To: Plan Holders for Improvements to the
Springfield-Branson National Airport
Springfield, Missouri
MoDOT Project No. AIR 126-092A1
West Kearney Terminal Parking Lot and GA Redevelopment

Transmitted herewith is **Addendum No. 2** to the Contract Documents, Plans and Specifications dated December 9, 2013 for Improvements to the Springfield-Branson National Airport, Springfield, Missouri, MoDOT Project No. AIR 126-092A1.

**ADDENDUM NO. 2
TO
CONTRACT DOCUMENTS, PLANS AND SPECIFICATIONS
FOR IMPROVEMENTS TO THE
SPRINGFIELD-BRANSON NATIONAL AIRPORT
SPRINGFIELD, MISSOURI
MoDOT PROJECT NO. AIR 126-092A1**

SHEET NAME
G014

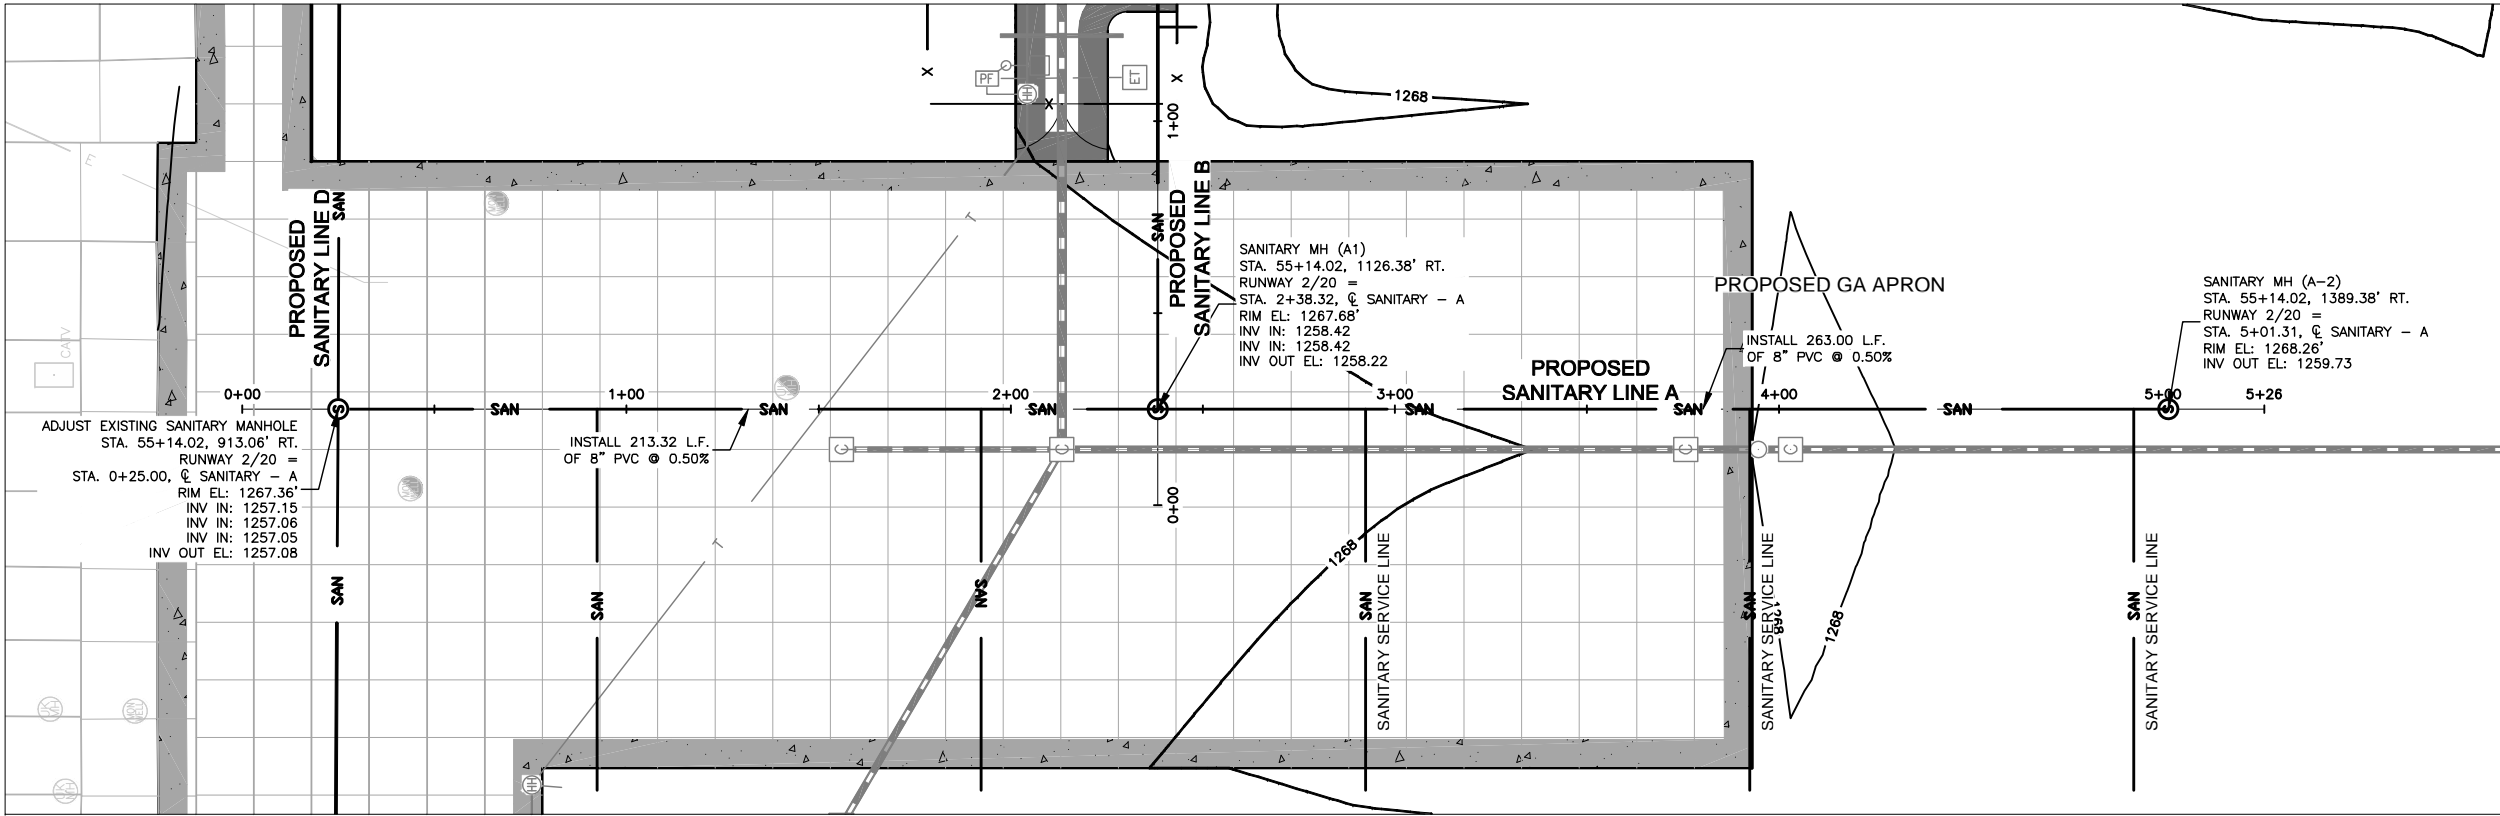
- a. Correct.
- r) Sheet G014 notes that Schedule II includes “paint obliteration” of the markings on the existing parking lot, but there does not appear to be an item included in the contract documents for pavement marking removal – will a new contract item be added for this work ?

- a. No, paint obliteration will not be required for Schedule II. See attached sheet G014.
- s) With a 4 calendar day window to complete each sub-phase of Schedule II, pavement markings will likely need to be placed the day after application of the pavement sealer - will this be an issue during construction? Should the durations of the sub-phases of Schedule II be increased to allow additional curing time of the pavement sealer?

PLAN AND PROFILE SANITARY LINE A		SHEET NAME C460
JVIATION PROJ. NO. AIR 126-092A1	DATE: 12/09/13	
		SHEET NO. 58 of 125

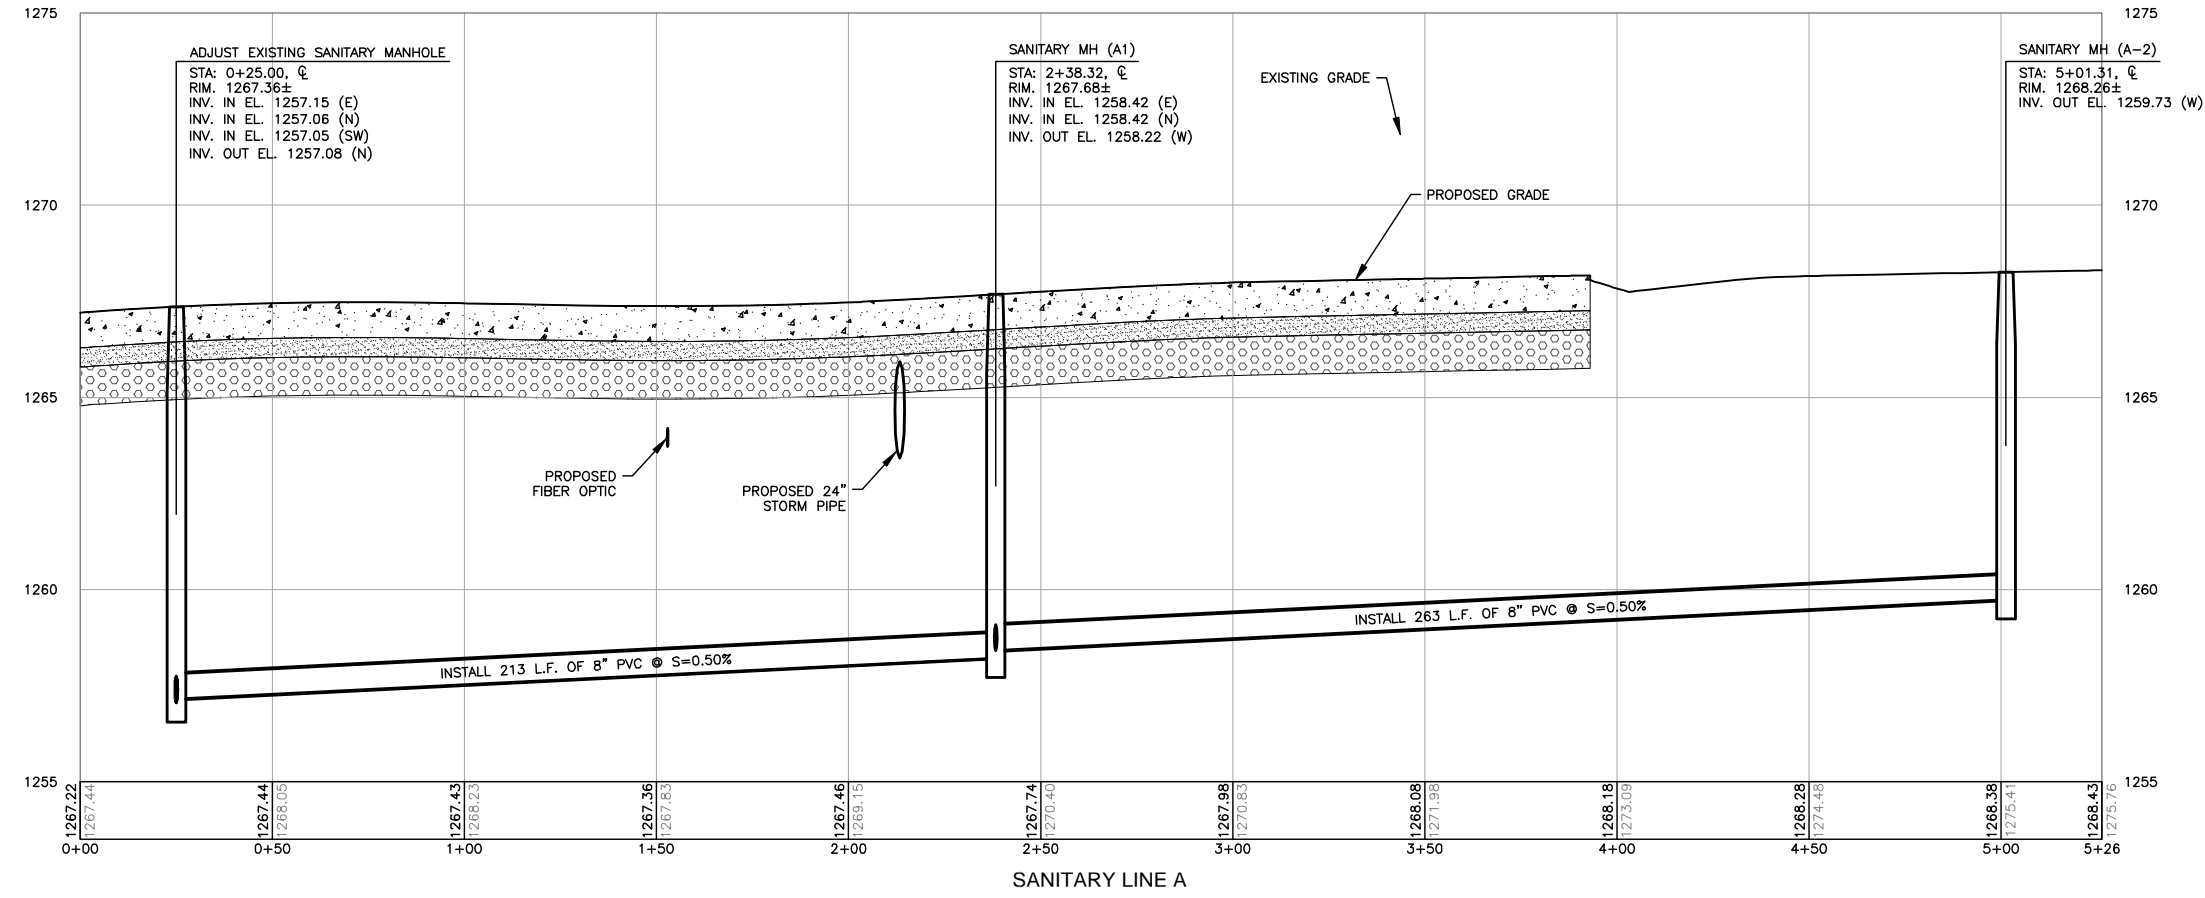
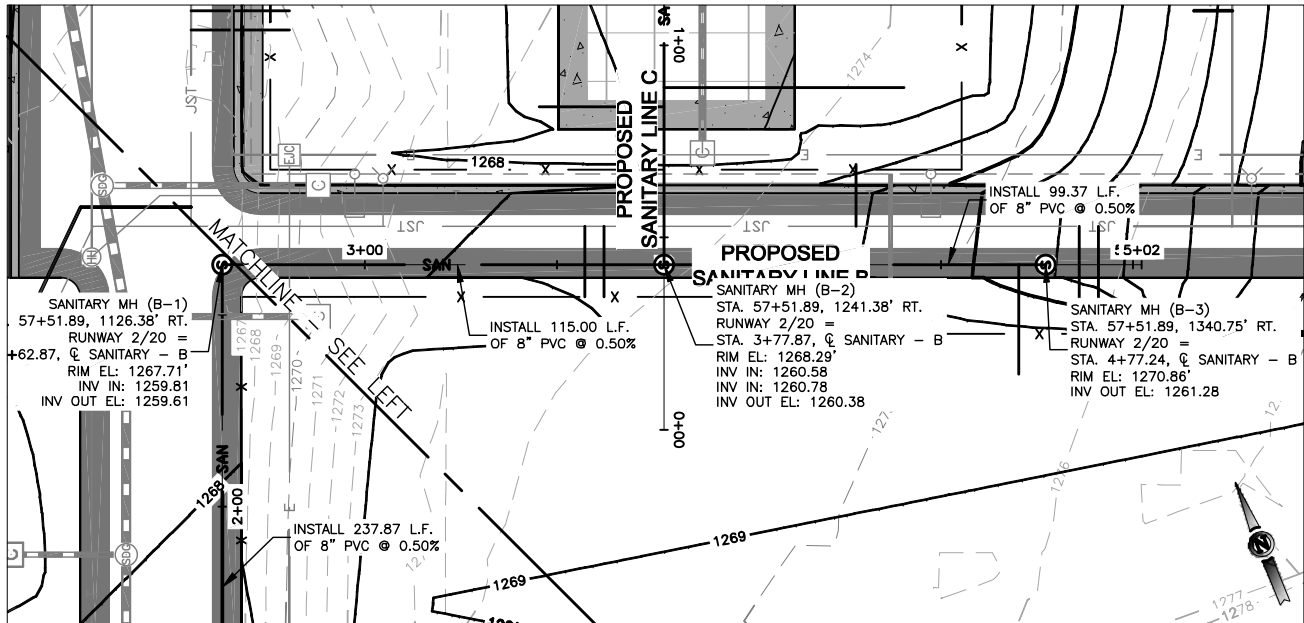
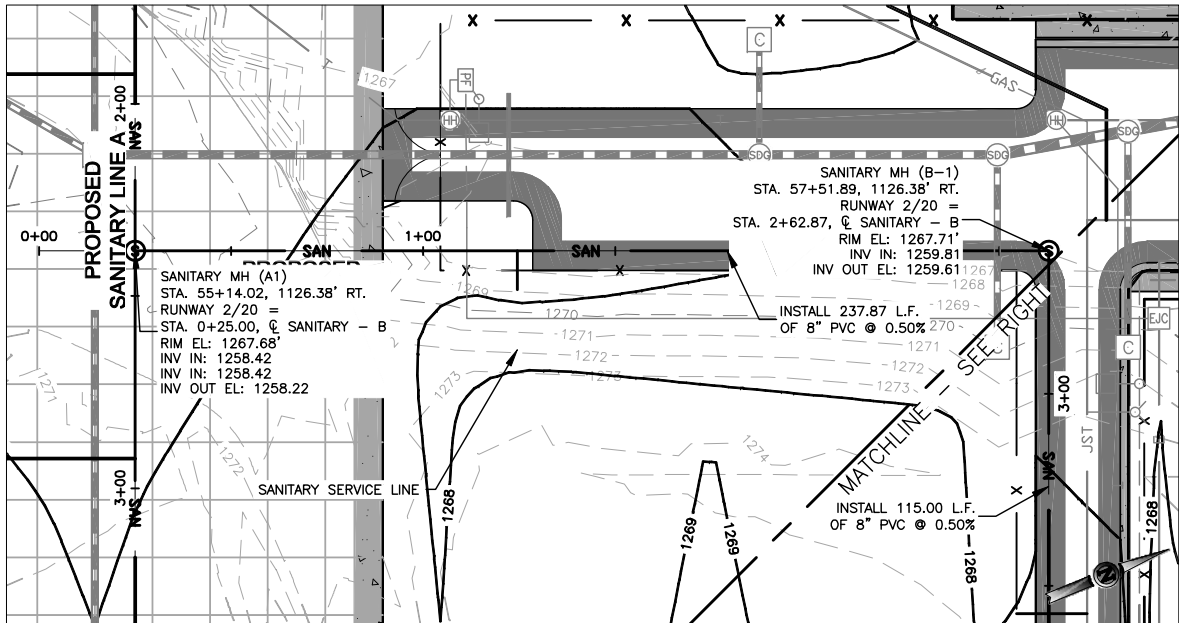
- i) Will utilities be measured by plan quantity or measured in the field?
 - a. The utilities will be measured in the field of the actual material installed. See additional note added for sanitary sewer requirements on Sheet C460 to C464.

SHEET NAME
E205

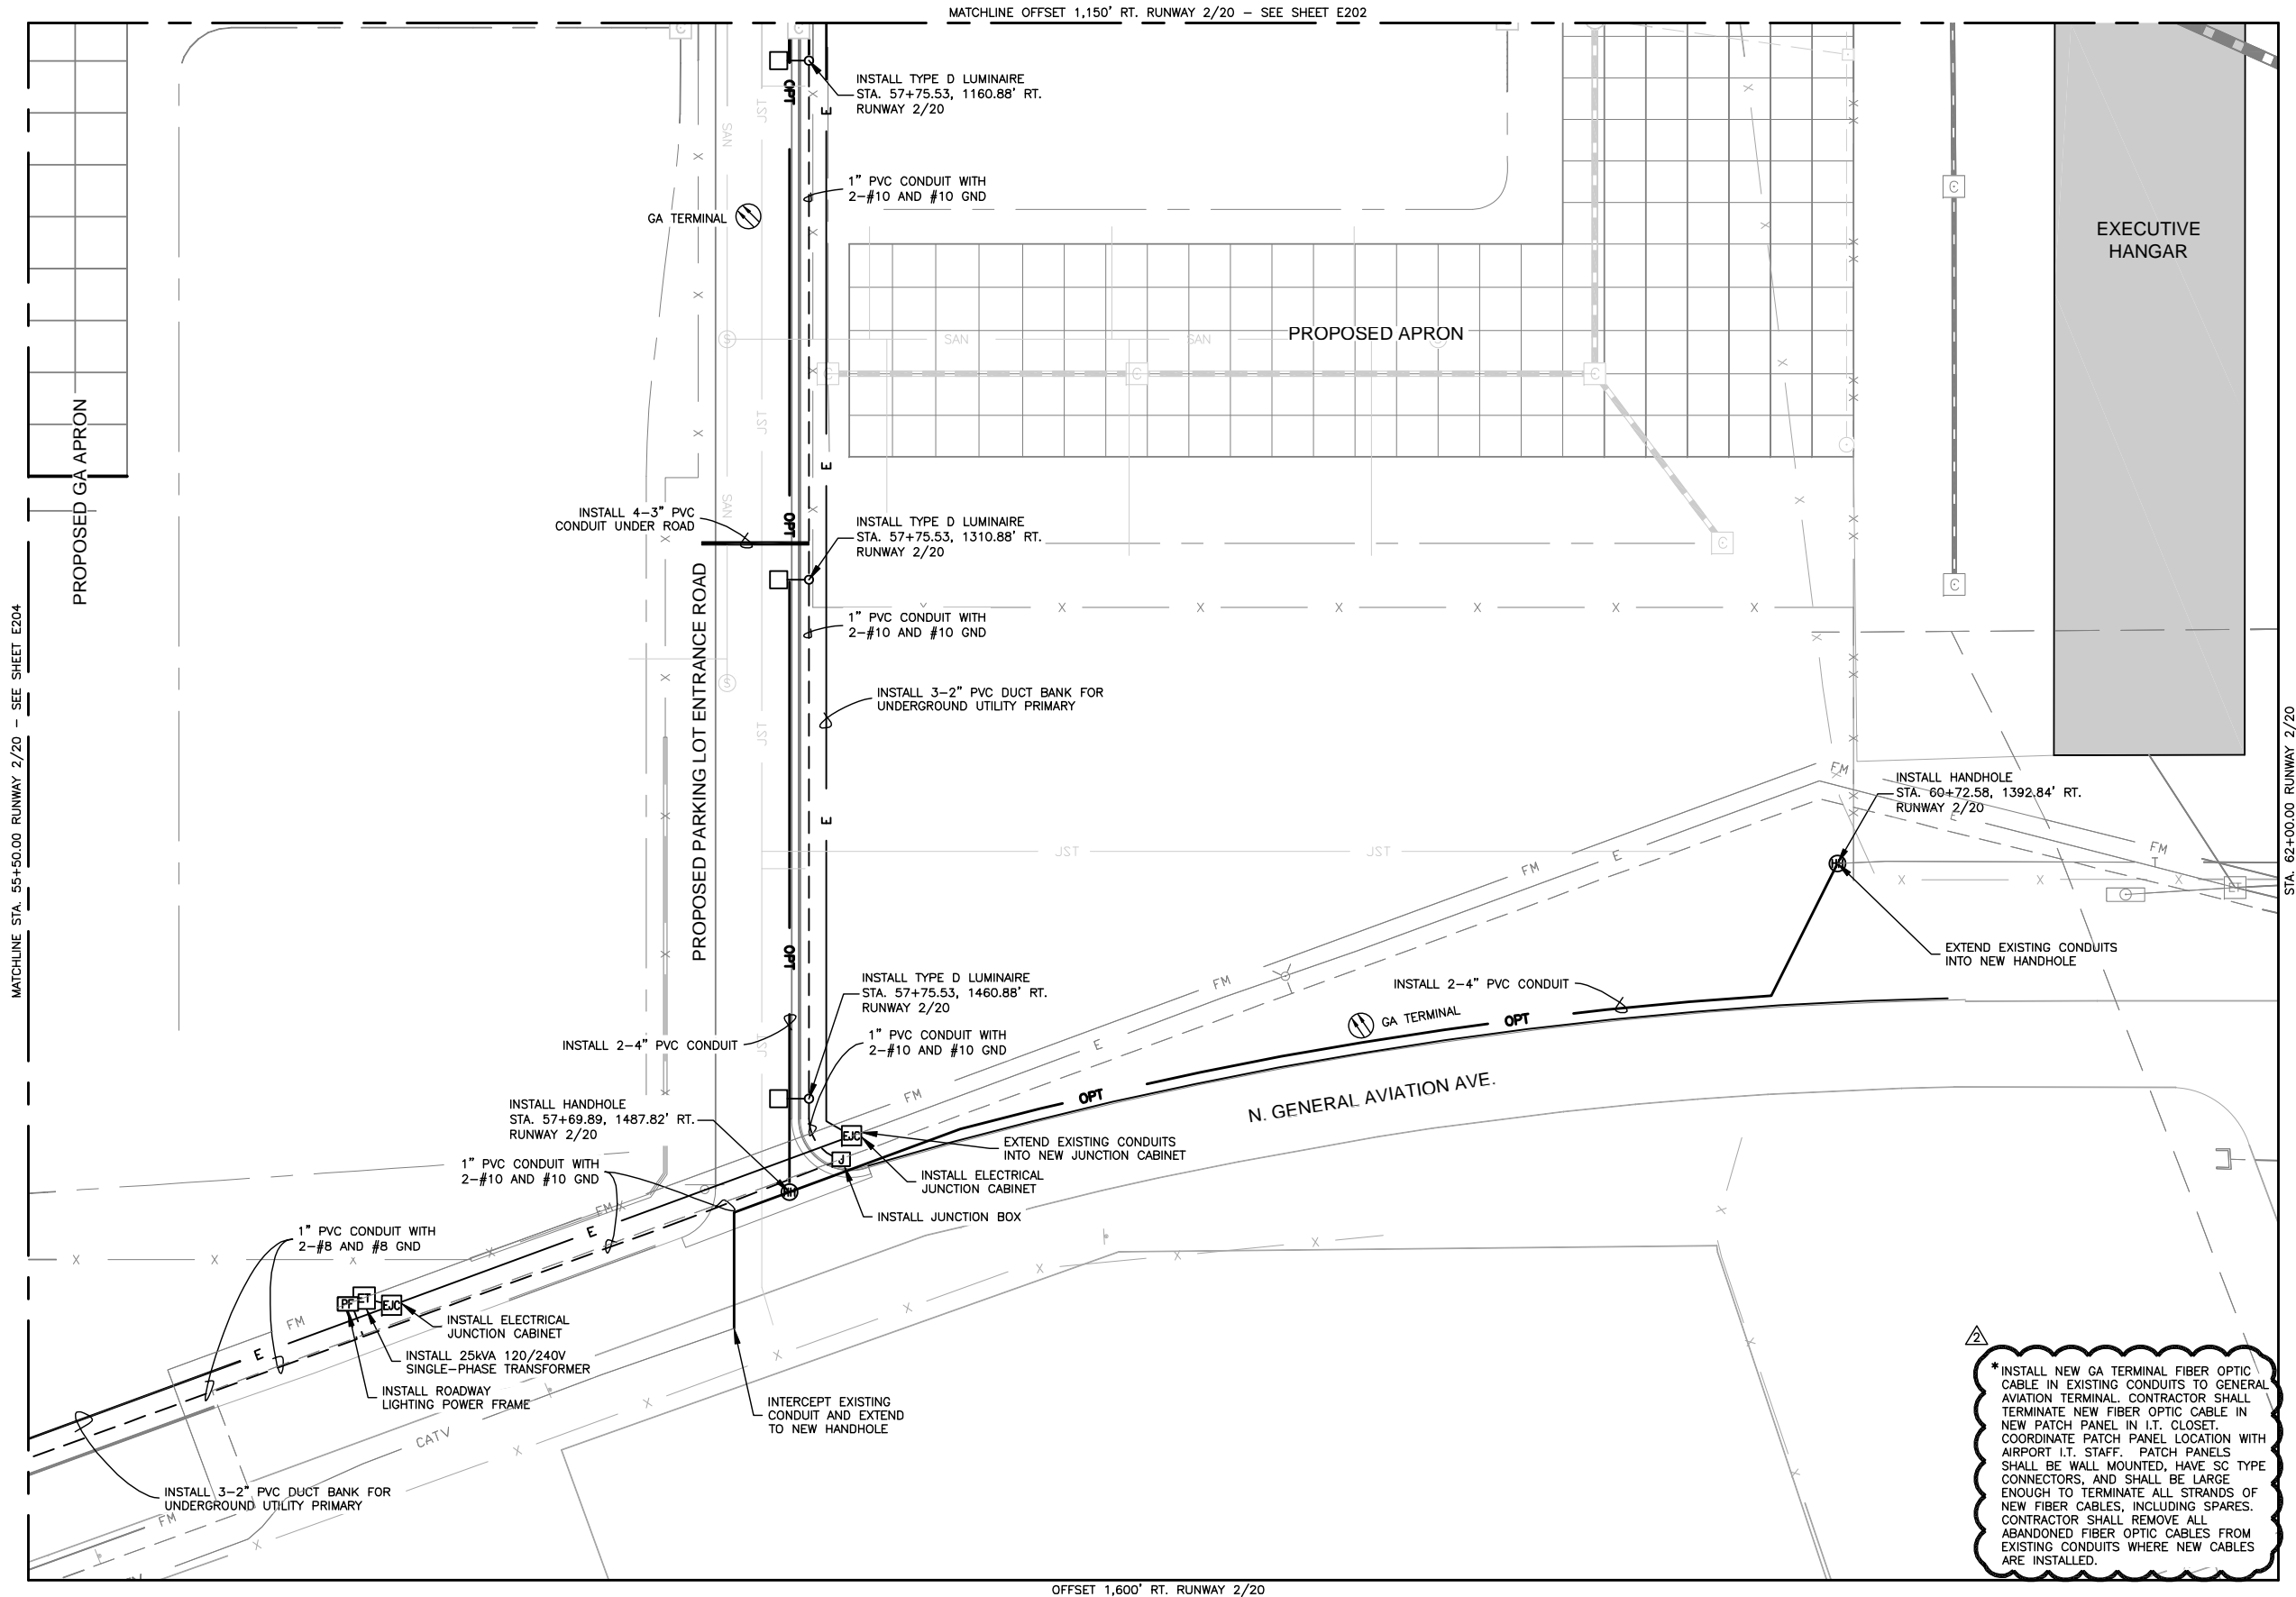
- o) Is there a specification for the fiber optic patch panels?
 - a. For additional information see attached Sheets E201 and E205.
- p) Based on the boring logs and limited amount of existing vegetation in the Schedule I work area, it appears that topsoil will be required for this project – will a new contract item be added for this work?

*INSTALL NEW GA TERMINAL FIBER OPTIC
CABLE IN EXISTING CONDUITS TO GENERAL
AVIATION TERMINAL. CONTRACTOR SHALL
TERMINATE NEW FIBER OPTIC CABLE IN
NEW PATCH PANEL IN I.T. CLOSET.
COORDINATE PATCH PANEL LOCATION WITH
AIRPORT I.T. STAFF. PATCH PANELS
SHALL BE WALL MOUNTED, HAVE SC TYPE
CONNECTORS, AND SHALL BE LARGE
ENOUGH TO TERMINATE ALL STRANDS OF
NEW FIBER CABLES, INCLUDING SPARES.
CONTRACTOR SHALL REMOVE ALL
ABANDONED FIBER OPTIC CABLES FROM
EXISTING CONDUITS WHERE NEW CABLES
ARE INSTALLED.
